Bid Date: June 14, 2016

UNK COLLEGE OF NURSING AND
ALLIED HEALTH DISTRIBUTED ANTENNA SYSTEM

PROJECT NO.	DATE	DRAWING REFERENCED:	T2.0	SKETCH
2015 5129	06/09/16	ADDENDUM NO.:	1	T S-01

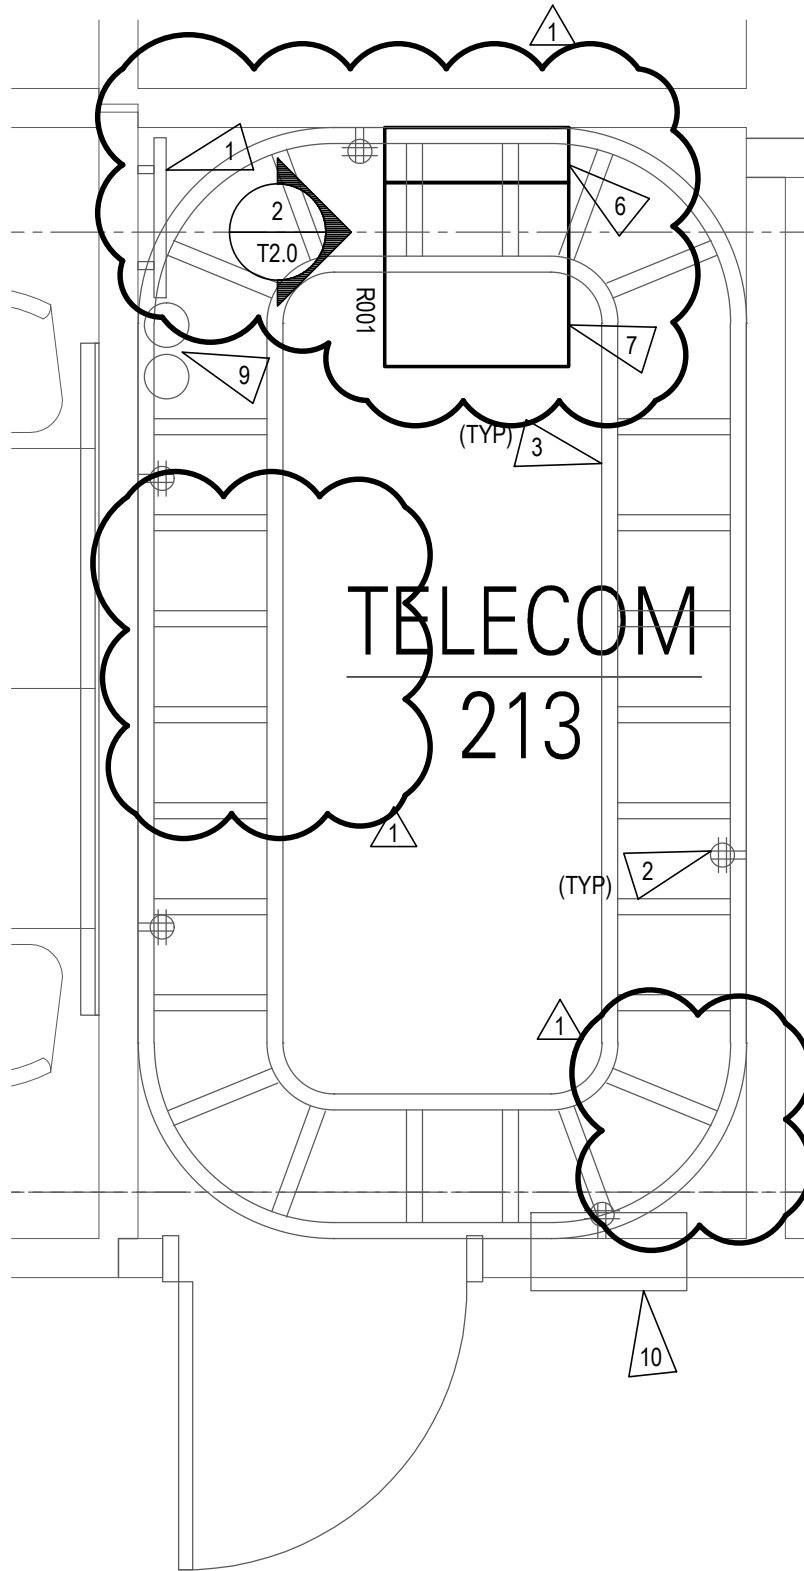
1TD1. Sheet T2.0 – Enlarged Plans, Schematics and Details

1. Enlarged Telecom Room 213: Modify equipment rack location as indicated on Sketch TS-01.
2. Donor Antenna Roof Mount: Modify detail note to read: “Existing roof carries a warranty. Coordinate all roof penetrations with UNK and Ziembra Roofing, Hastings NE (402) 462-8382.”
